RE: 36 Warry Street, Fortitude Valley – Refuse Management Response to Information Request

Colliers International Engineering & Design (TTMC) Pty Ltd has been engaged to review and provide a written response to the **Waste Management** commentary outlined in the Request for Further Information (RFI) letter received on 27 March 2026 issued by Brisbane City Council (BCC).

Project
BAKERS GROUND
36 Warry St & 37 Kennigo St,
Spring Hill, 4000

Project Number 964KEN Drawing Number A-DA 204 Issue E

Figure 1: Revised residential refuse storage arrangements

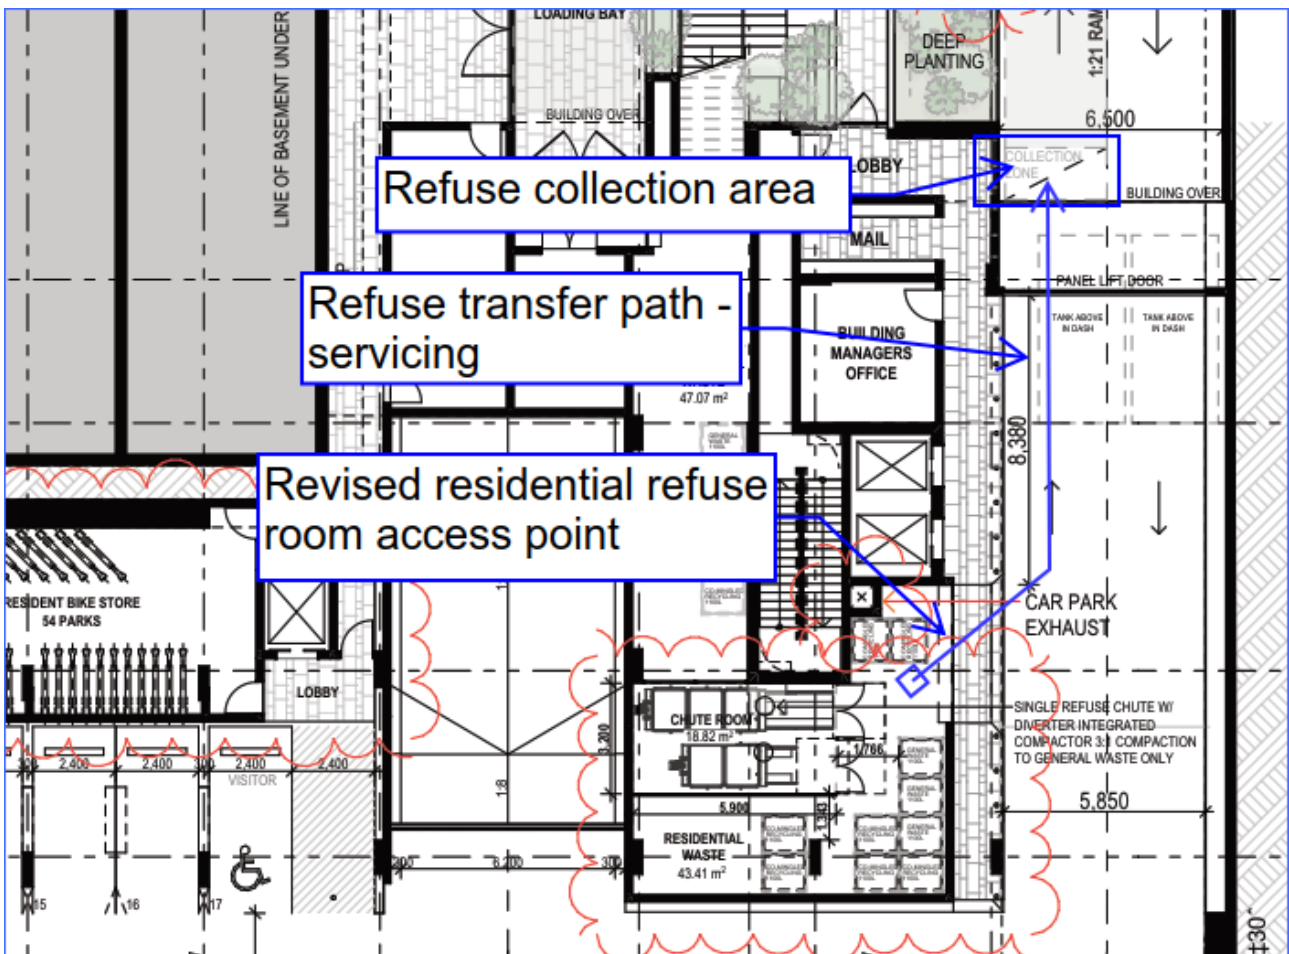
The proposed plans show the 'Residential Waste' room and the 'Commercial Waste' room are greater than 5m from the Refuse Collection Vehicle (RCV), whilst it is unclear how bins will be moved from the Commercial Waste room to the RCV zone. In accordance with PO63/AO63.1 & AO63.2 of the Centre or mixed use code, PO32/AO32 of the Multiple dwelling code and PO8/AO8.1 & AO8.2 of the Infrastructure design code, demonstrate the following:

a. Demonstrate on amended plans a refuse storage/collection point for both commercial and residential bins that is within 5m of the RCV. The residential bins must be stored and collected separately from the commercial bins.

b. Demonstrate the transfer path for bulk bins from the storage/collection point to the RCV does not include gradients greater than 1:20.

c. If proposed to collect commercial bins from the MRV and SRV bay, it will need to be demonstrated how this is intended to function and it is anticipated that collection would need to be completed by a private contractor with a smaller vehicle (i.e. 8.0m-8.8m long)

Architectural drawings have been amended to reflect changes to the residential refuse storage areas that result in improved efficiency in the servicing of residential refuse. While the overall storage area sizing is consistent with the original submission, the layout has been refined:

The refuse chute and hoppers on each residential level have been relocated within the services rooms on each level with the chute offsetting from the mezzanine level to discharge in a new location within the residential refuse room on Lower Ground level. The revised chute discharge location enables the repositioning of the bin rotation equipment and surrounding safety partition.

Subsequently, these refinements enable the relocation of bins within the room as well as a repositioning of the room access door, now located approximately 15m closer to the RCV standing position. While Colliers acknowledge that a performance solution in relation to bin transfer distance is still proposed, the distance between the refuse room has been significantly reduced and now measures approximately 11m.

The areas accessed by the residential refuse collection contractor feature a ramp grade of 1:21 at the steepest point and while greater than 1:20 is considered appropriate as the ramp is of a gentler gradient.

Figure 1 illustrates the revised residential refuse storage area in context of the refuse servicing area.
